| CHANGE DATE | CHANGE DESCRIPTION                              | CHANGE NO.                   | NAME | <div>SportsArt</div> <div>FITNESS</div> <div>RESTRICTED USAGE ,</div> <div>PLEASE DON'T FORWARD TO ANYONE WHO ISN'T AUTHORIZED</div> |  | DRAWN BY |  | UNITS   | MM   | SALES BLOW UP DIAGRAM | DIAGRAM NO. | TBK-F101B-C    |

| CHANGE DATE | CHANGE DESCRIPTION                                                                                                                                                                       | CHANGE NO.   | NAME | <div>SportsArt</div> <div>FITNESS</div> <div>RESTRICTED USAGE ,</div> <div>PLEASE DON'T FORWARD TO ANYONE WHO ISN'T AUTHORIZED</div> | DRAWN BY    |  | UNITS | MM | SALES BLOW UP DIAGRAM | DIAGRAM NO. | TBL-F101C-E |

| CHANGE DATE | CHANGE DESCRIPTION    | CHANGE NO.   | NAME | <div>SportsArt</div> <div>FITNESS</div> <div>RESTRICTED USAGE ,<br/>PLEASE DON'T FORWARD TO ANYONE WHO ISN'T AUTHORIZED</div> |  | DRAWN BY | UNITS   | MM   | SALES BLOW UP DIAGRAM | DIAGRAM NO. | TBL-F101D-C |

| CHANGE DATE |  | CHANGE DESCRIPTION

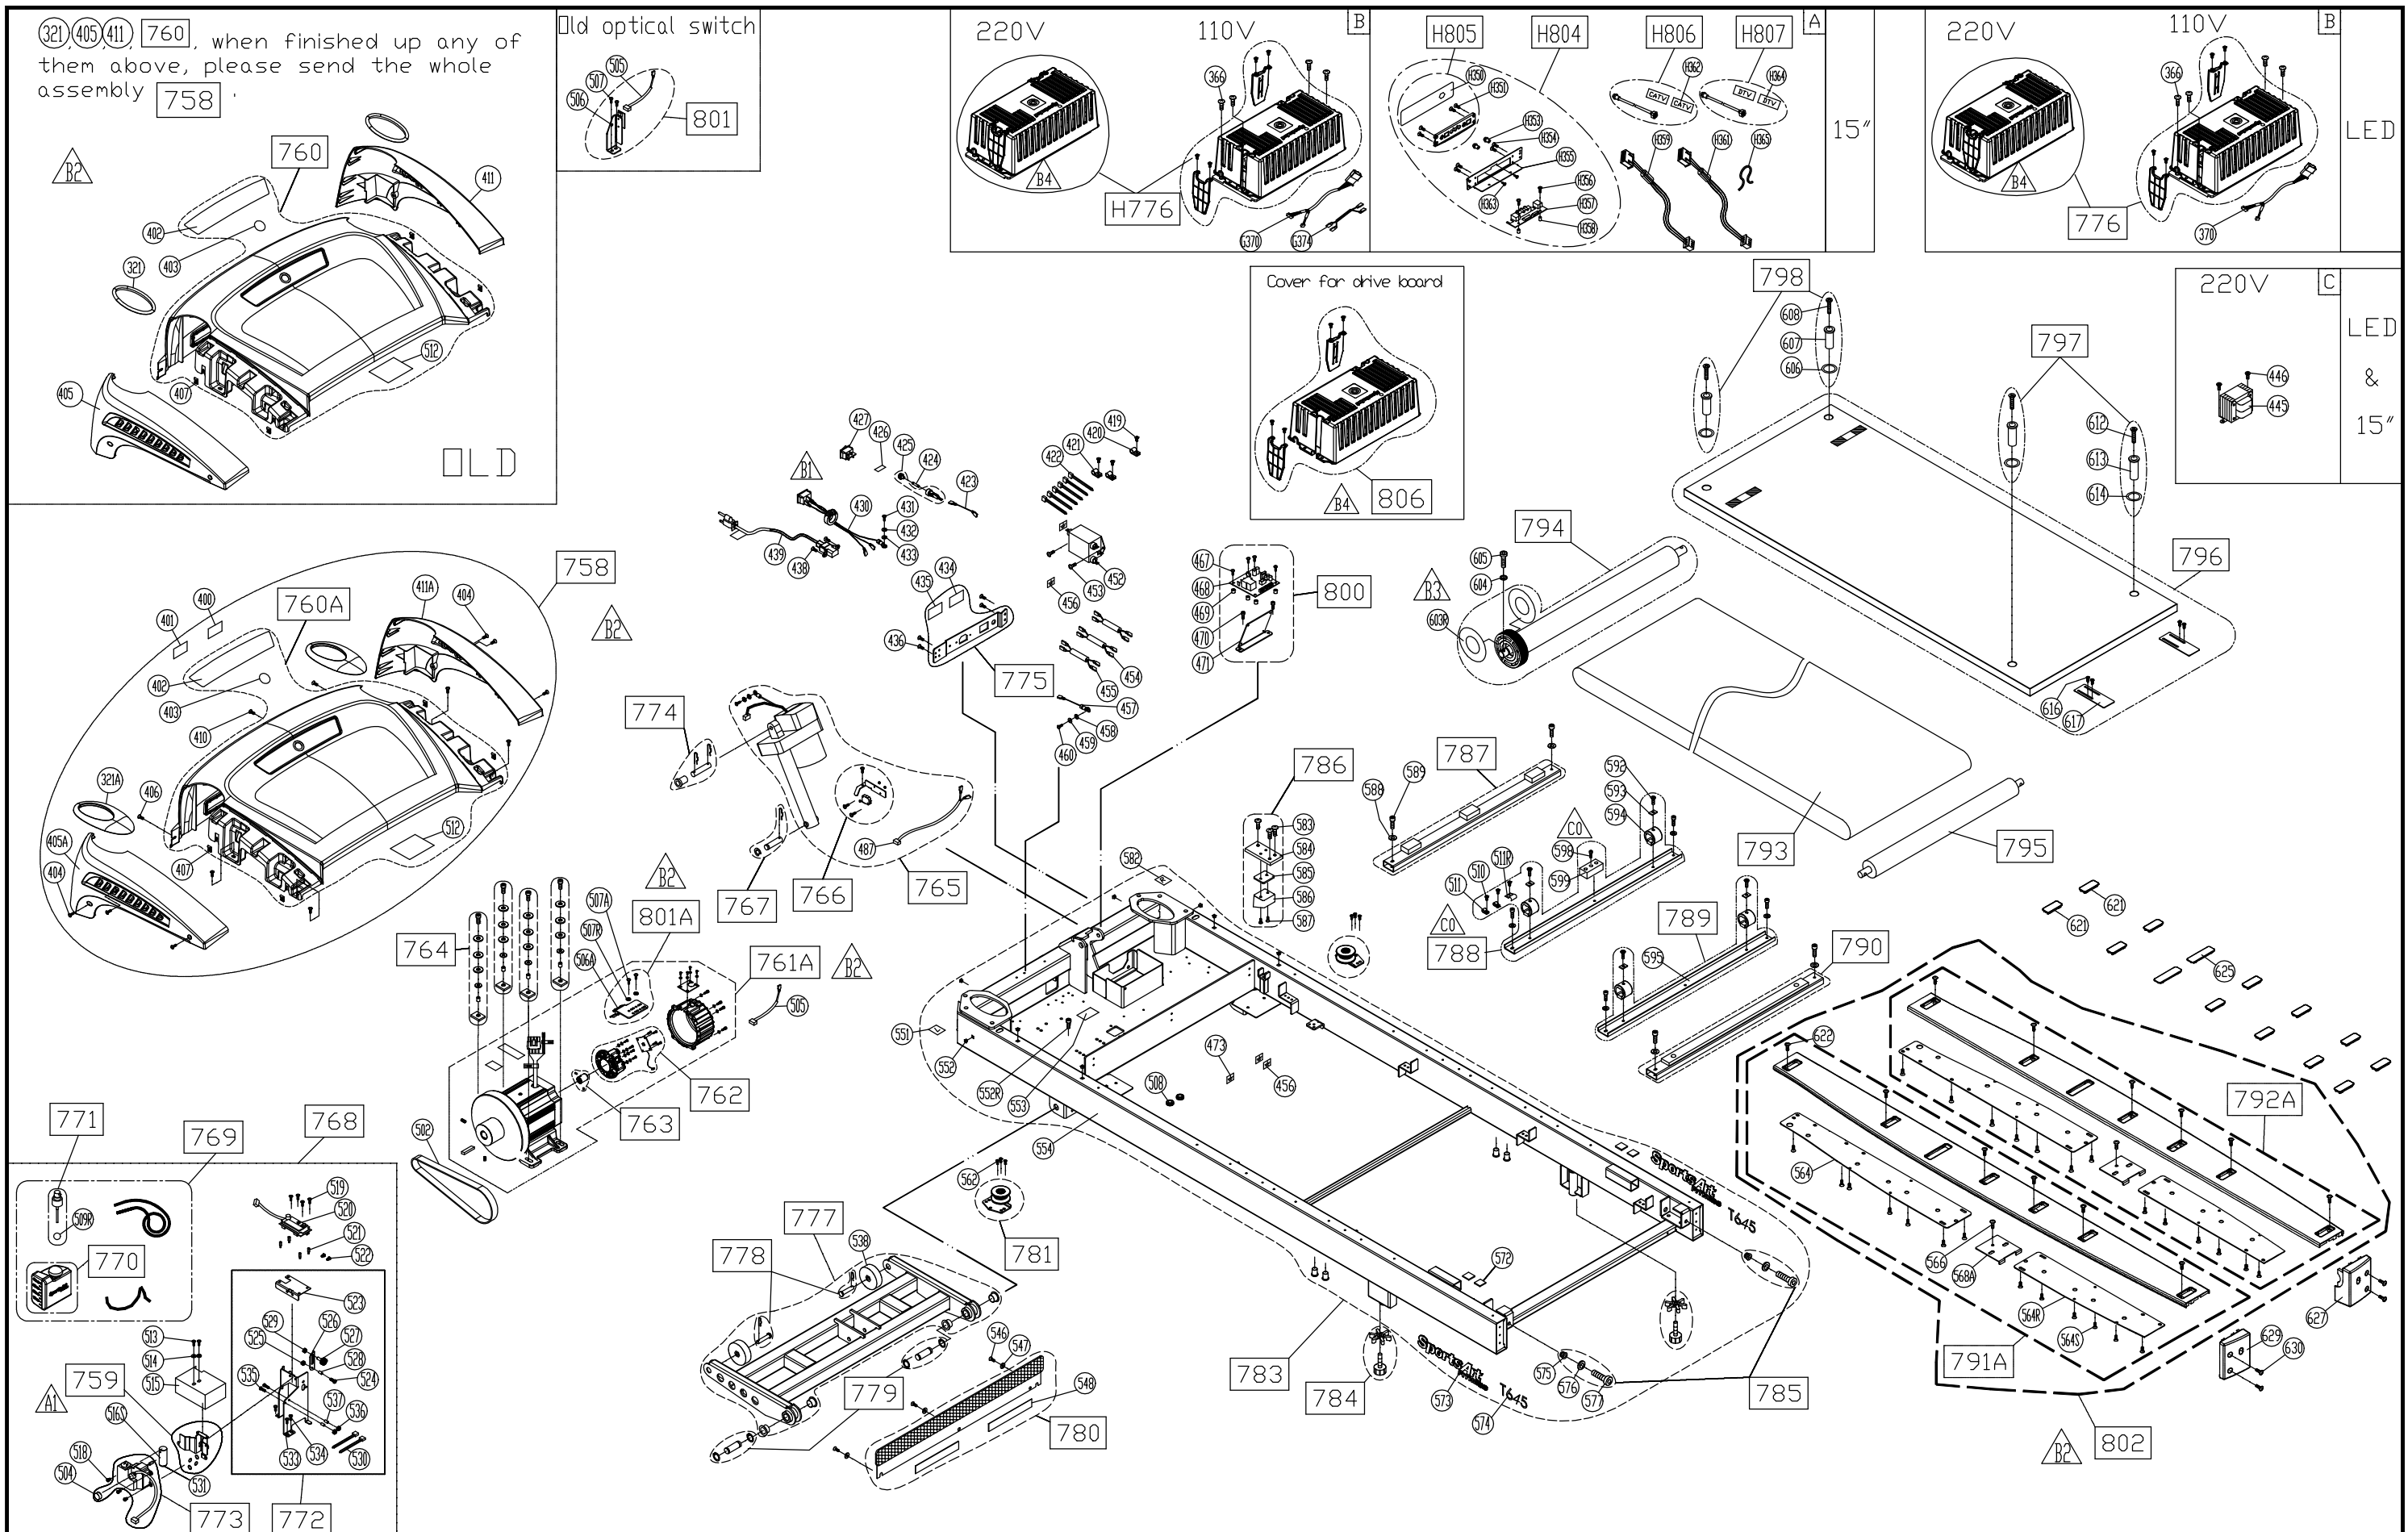
| CHANGE DATE | CHANGE DESCRIPTION    | CHANGE NO.   | NAME | <div>SportsArt</div> <div>FITNESS</div> <div>RESTRICTED USAGE ,<br/>PLEASE DON'T FORWARD TO ANYONE WHO ISN'T AUTHORIZED</div> |  | DRAWN BY | UNITS   | MM   | SALES BLOW UP DIAGRAM | DIAGRAM NO. | TBL-F101D-C |
|-------------|-----------------------|--------------|------|-------------------------------------------------------------------------------------------------------------------------------|--|----------|---------|------|-----------------------|-------------|-------------|
| 2016.10.05  | ▲B4 新增 806            |              | 張又仁  |                                                                                                                               |  |          | QTY     | 1    |                       |             | T645        |
| 2016.11.30  | ▲C0 新增 599 599 修改 788 | 02-20161119M | 尤淑芬  |                                                                                                                               |  |          | VERSION | C0   |                       |             | MODEL       |
| 2016.01.07  | ▲B3 新增 6030*2PCS      |              | 尤淑芬  |                                                                                                                               |  |          | RATIO   | 1:16 |                       |             |             |

OLD→NEW   
 Replace **D409A** or **D410A**,  
 please send one set  
**D411**.

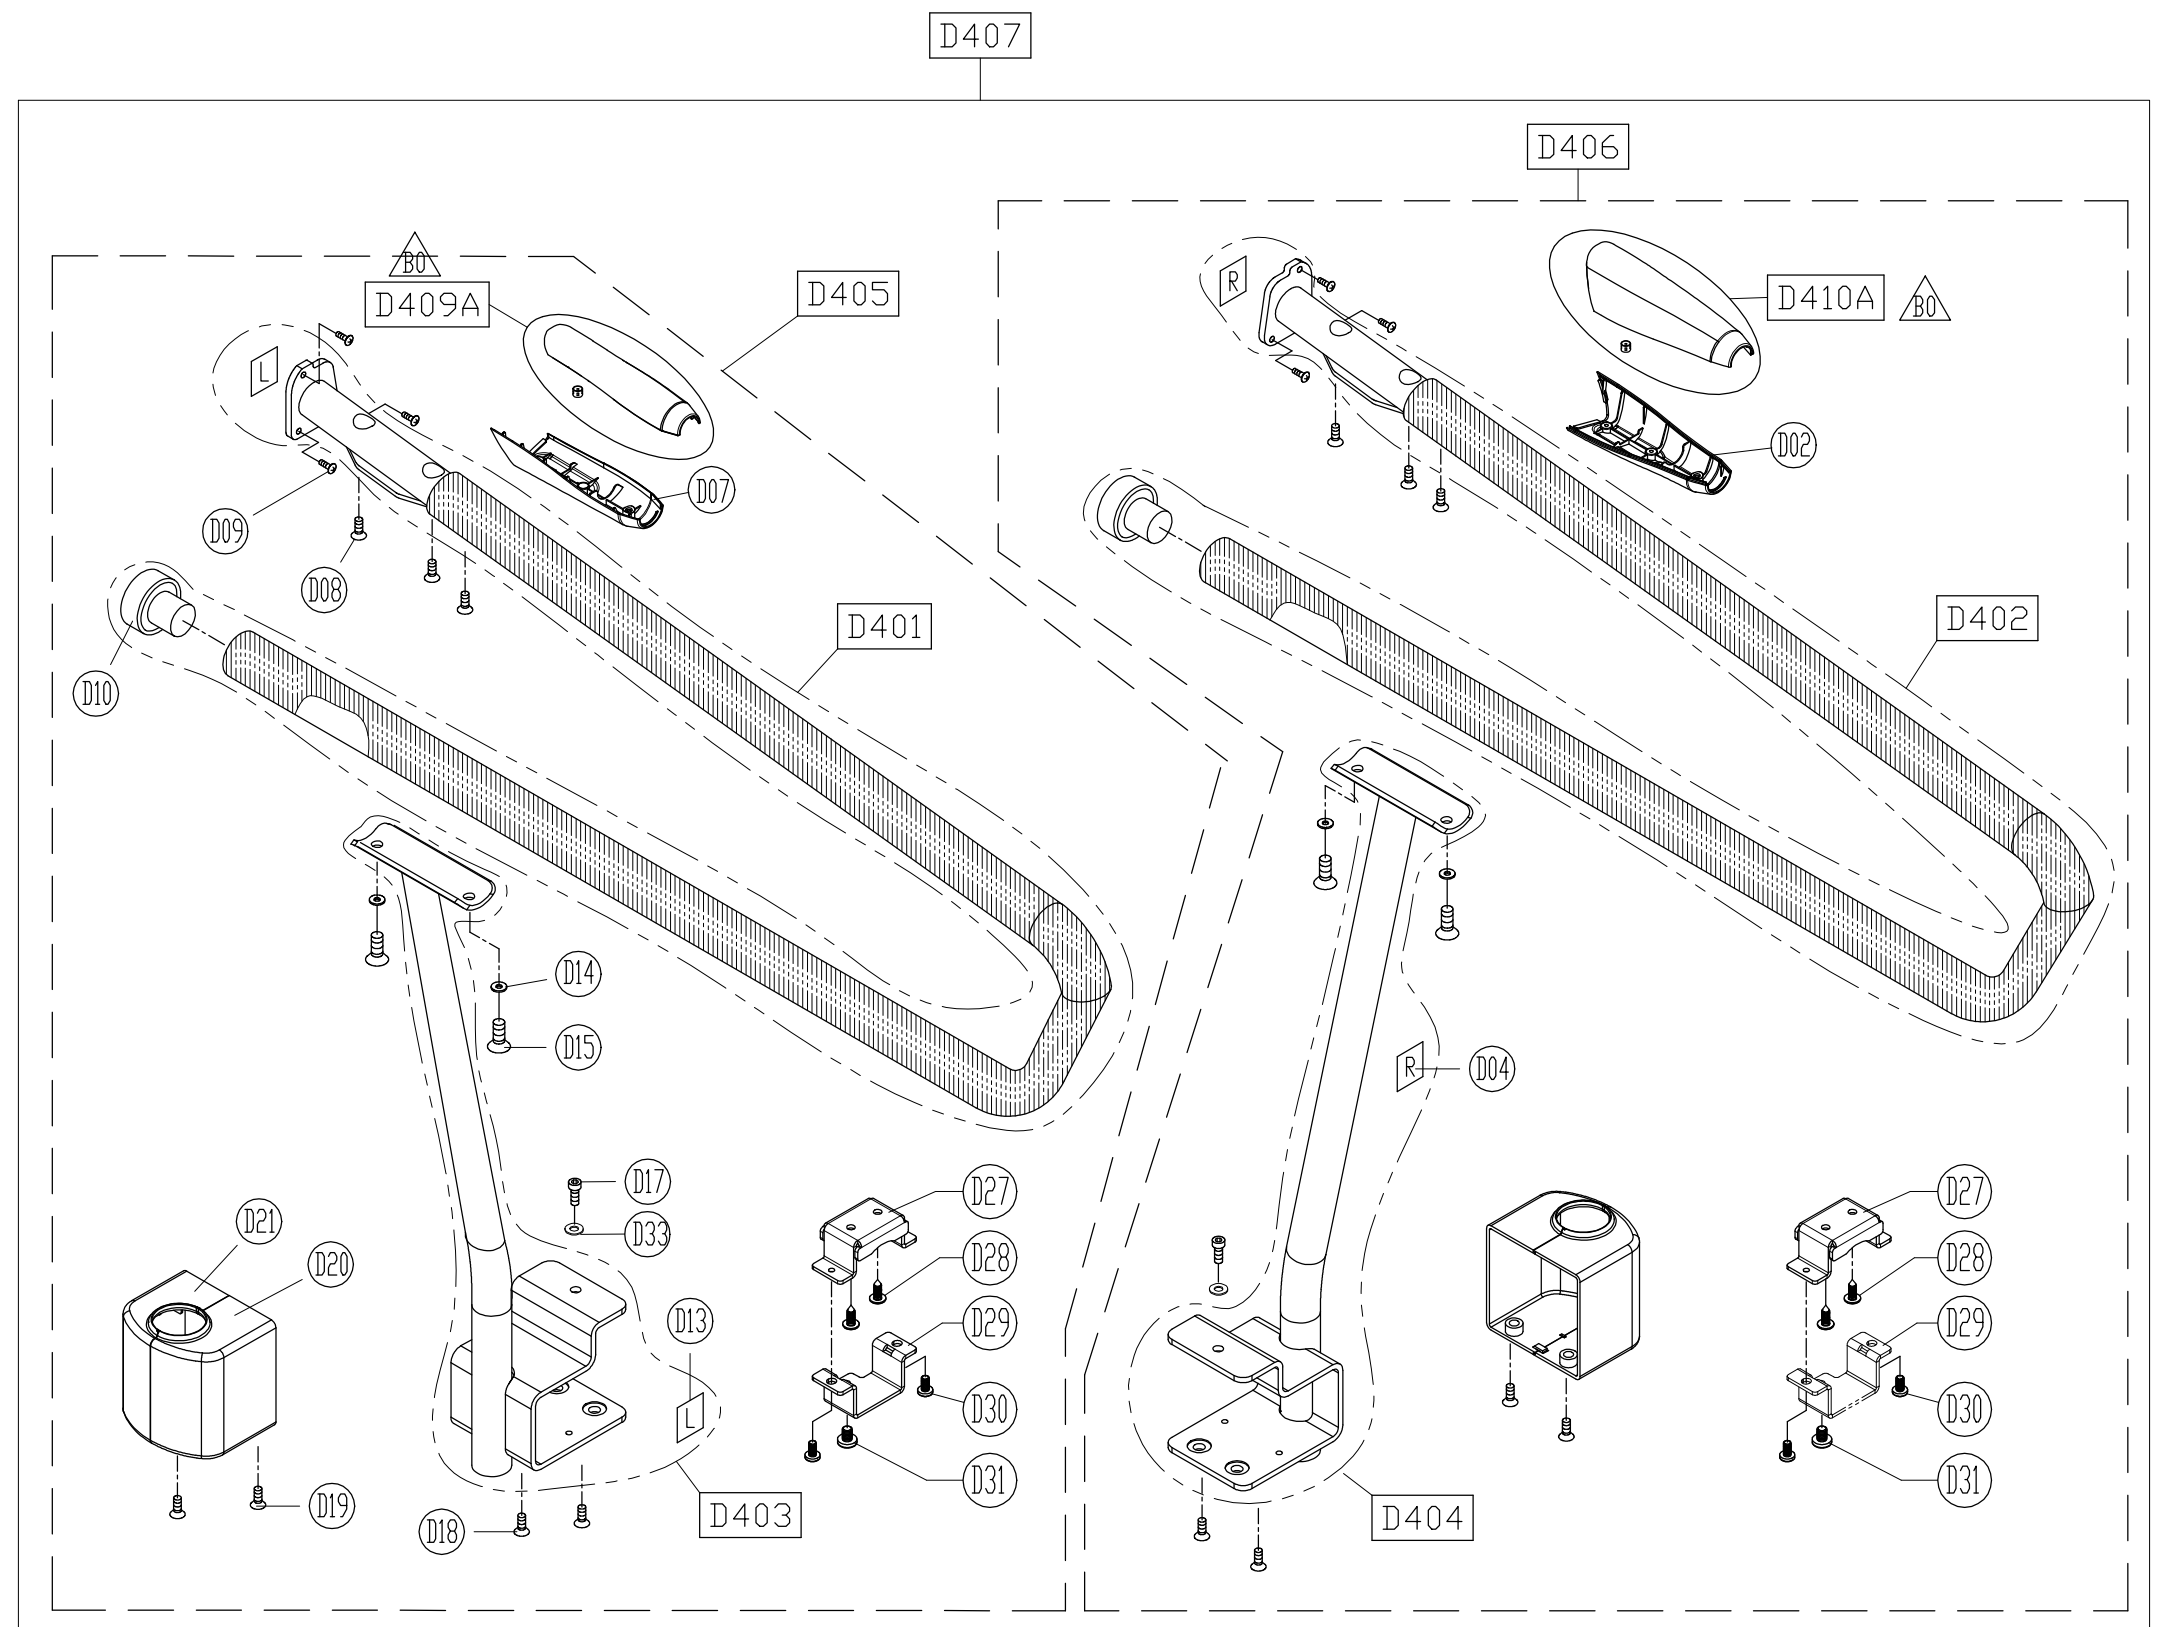
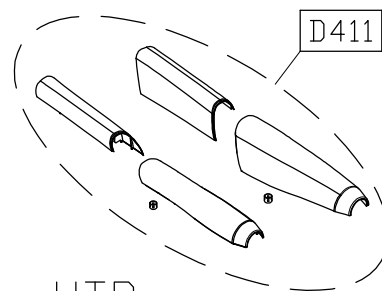
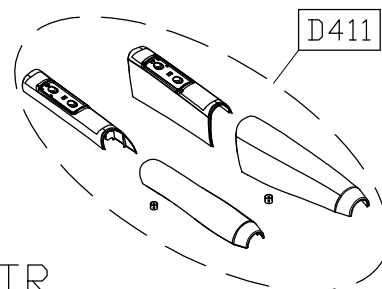
| CHANGE DATE |  | CHANGE DESCRIPTION                                                                                                                                                          | CHANGE NO.   | NAME | Long handrail assy.(R&L) |  | UNITS   | MM  | SALES BLOW UP DIAGRAM | DIAGRAM NO. | TBL-F101E-B        |
|-------------|--|-----------------------------------------------------------------------------------------------------------------------------------------------------------------------------|--------------|------|--------------------------|--|---------|-----|-----------------------|-------------|--------------------|
| 2015.10.26  |  |  扶手護蓋補強, 舊換新須搭配寄整組 <b>D411</b> ; <b>D409</b> 改 <b>D409A</b> ; <b>D410</b> 改 <b>D410A</b> | 02-20150619M | 楊淵堯  | DRAWN BY                 |  | QTY     | 1   | XX                    | MODEL       | T645/T635<br>T635M |
